**CITY OF WELLSBURG  
BROOKE COUNTY, WEST VIRGINIA**

**CONTRACT #1 MAIN ST., CHARLES ST., AND COMMERCE ST. WATERLINE  
REPLACEMENT PLAN**

**ADDENDUM #3**

**THRASHER PROJECT #101-010-1117**

**#12**  
**INTERCONNECTION DETAIL CHARLES ST. AND 5th ST.**

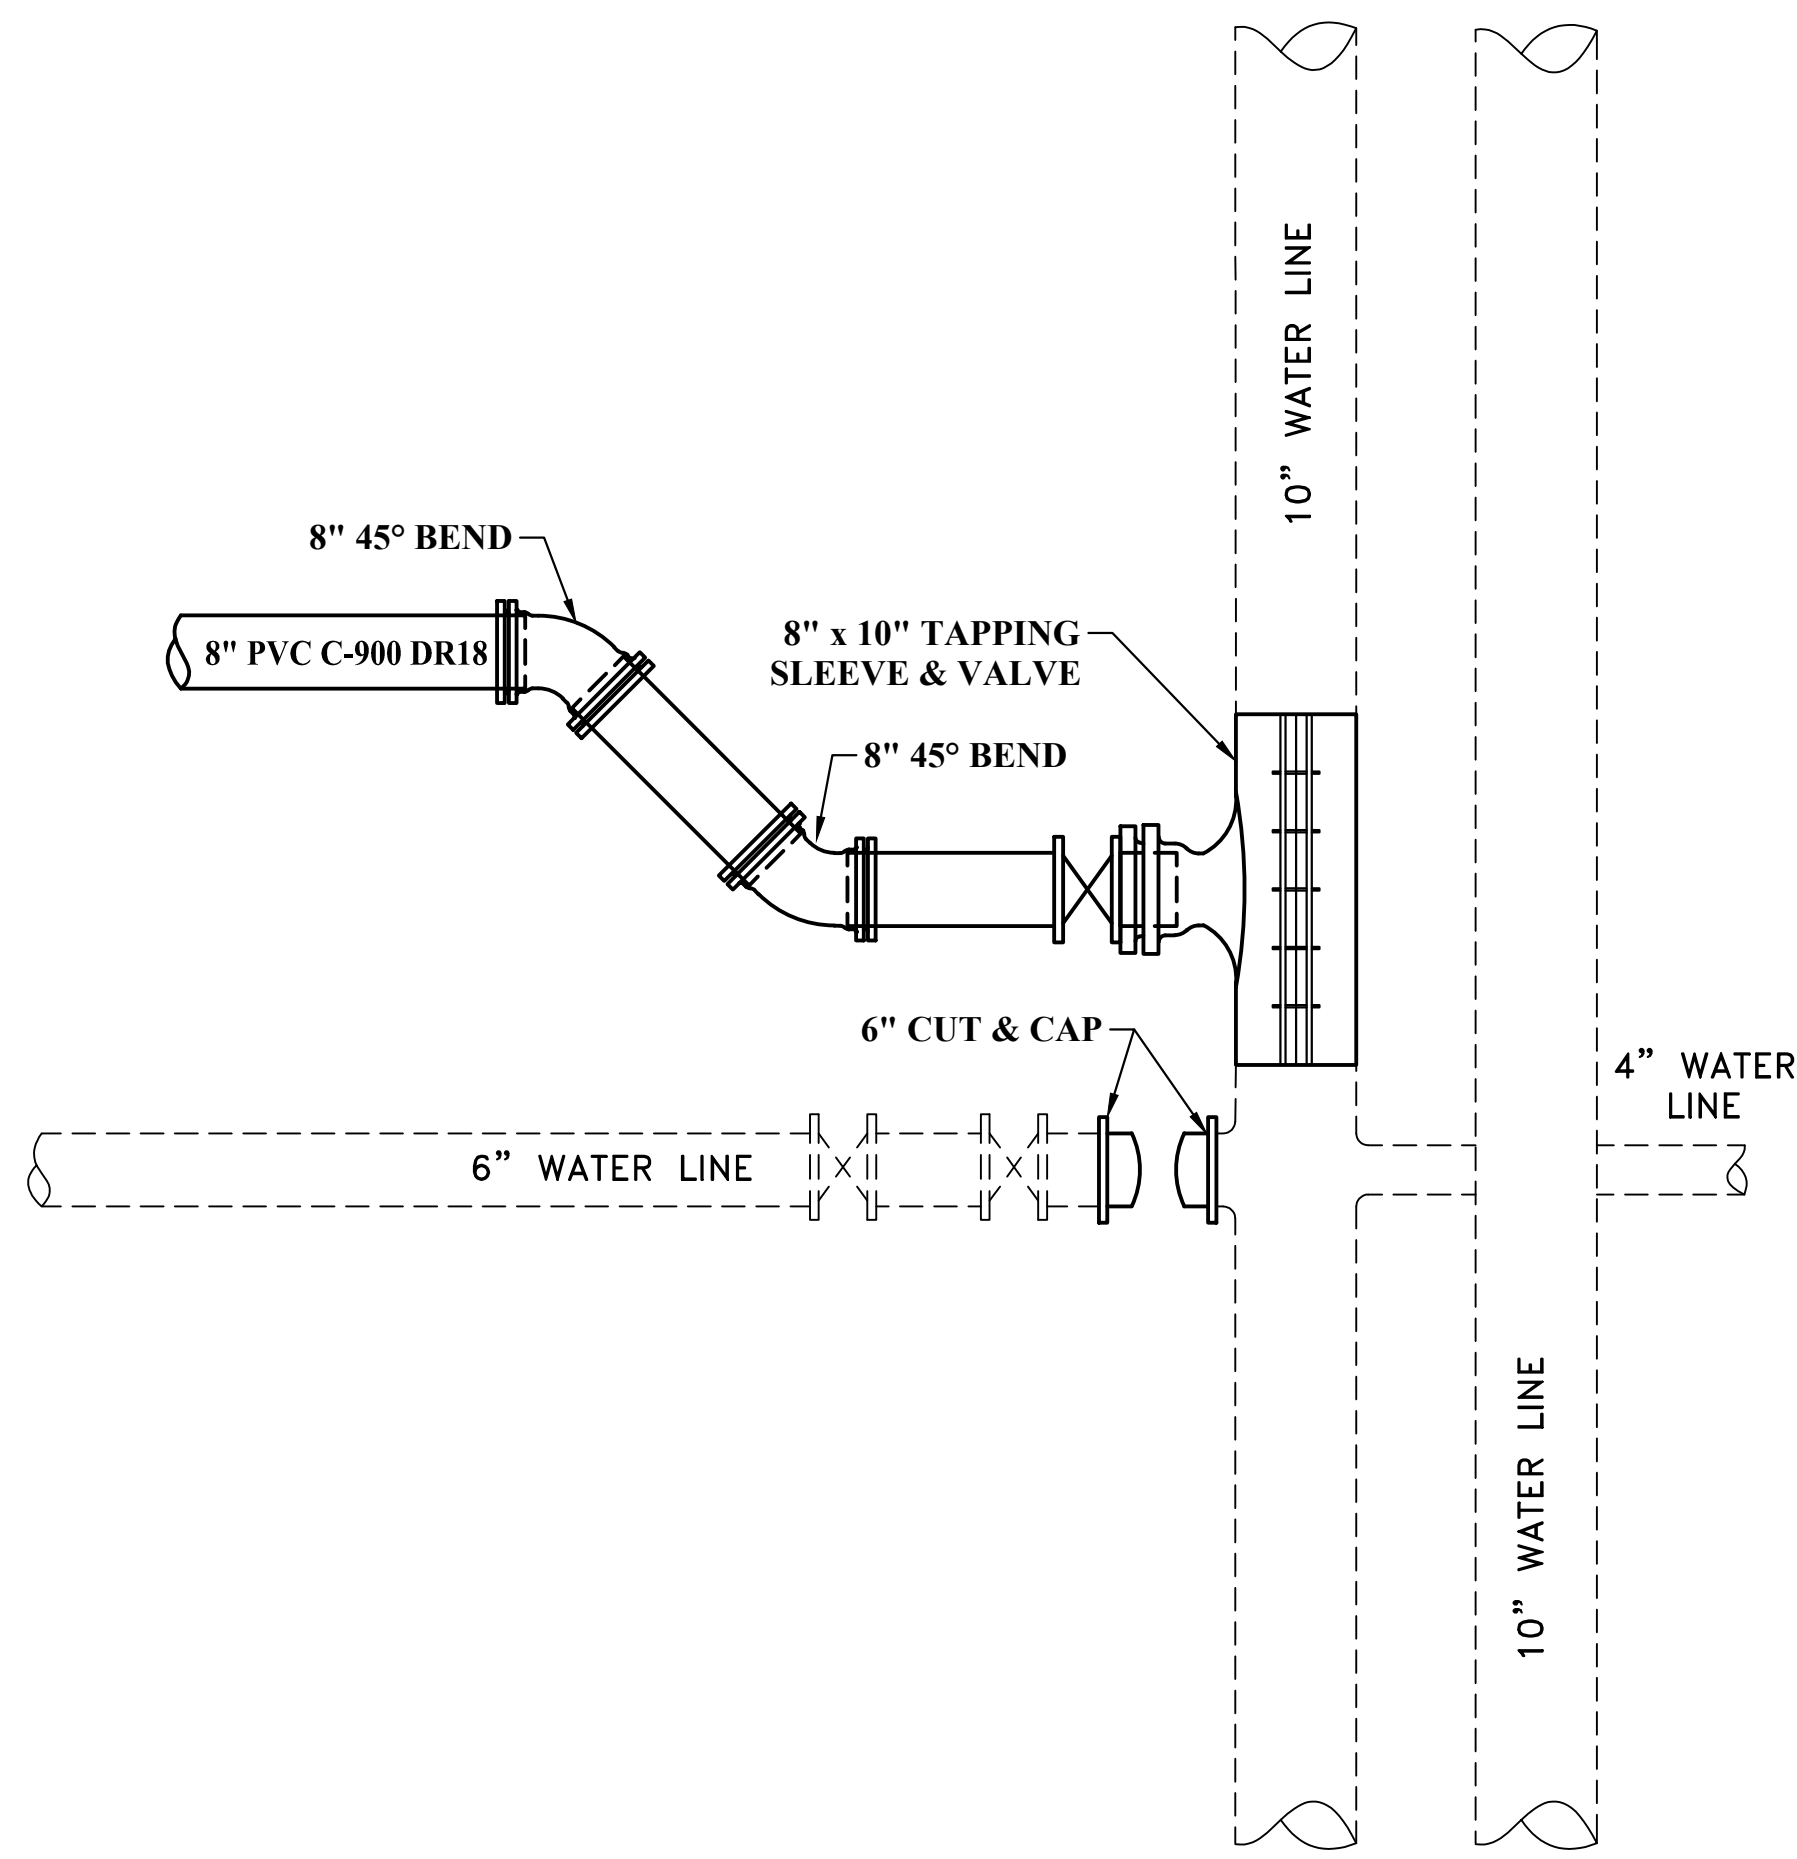
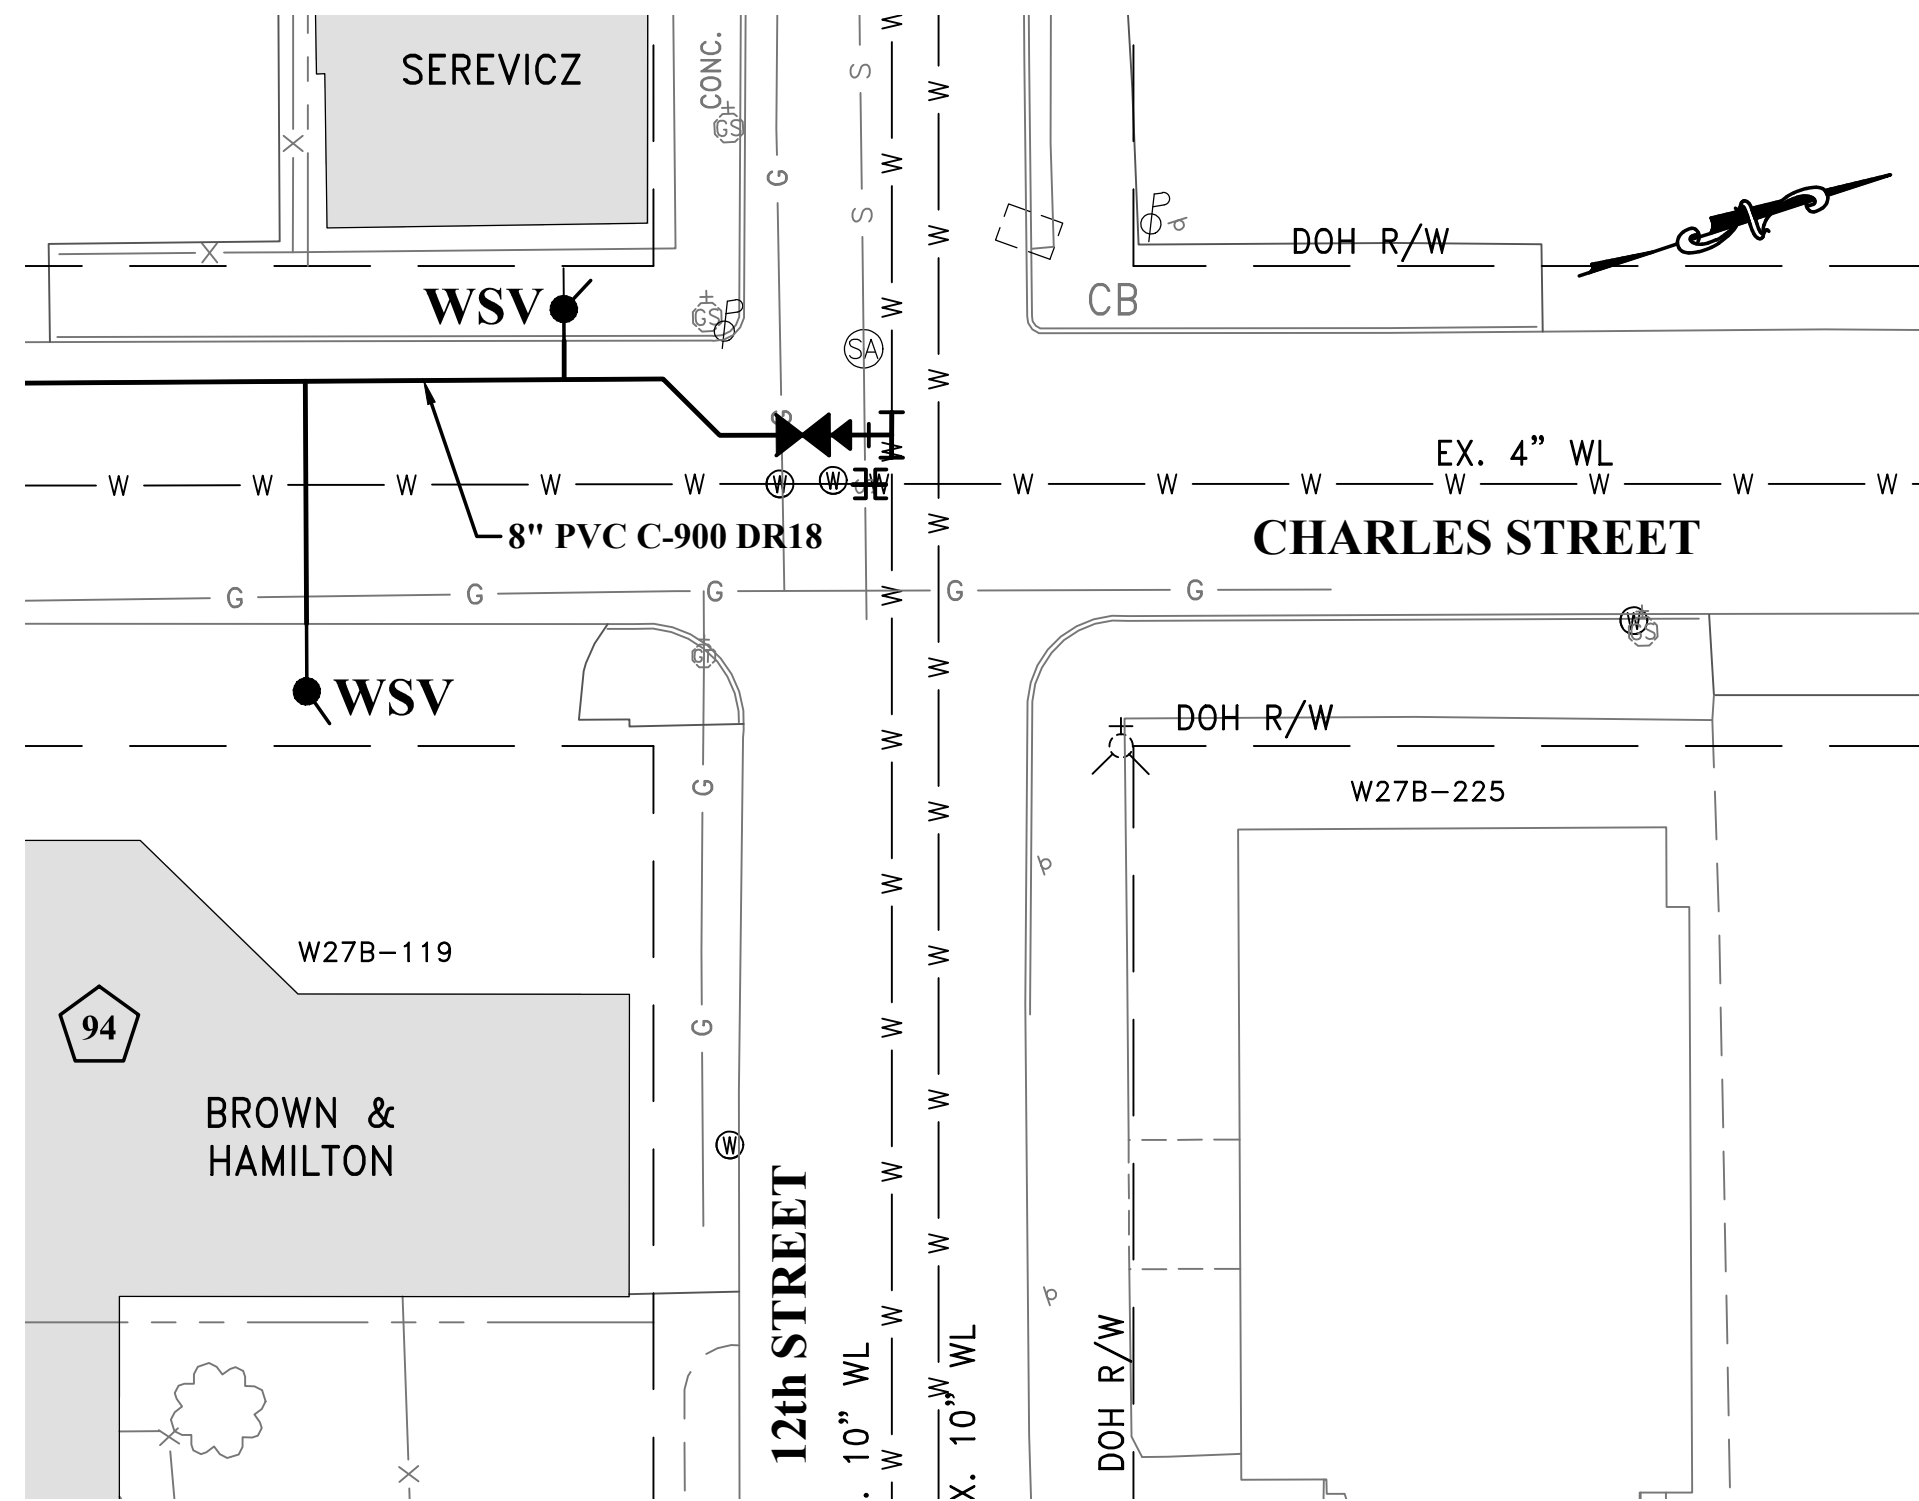
1. Plan Sheet 13, Interconnection detail #12, removed the extra gate valve.
2. Plan Sheet 15, Interconnection detail #19, revised to correctly show a 6" x 6" Hot Tap and not 6" x 8".
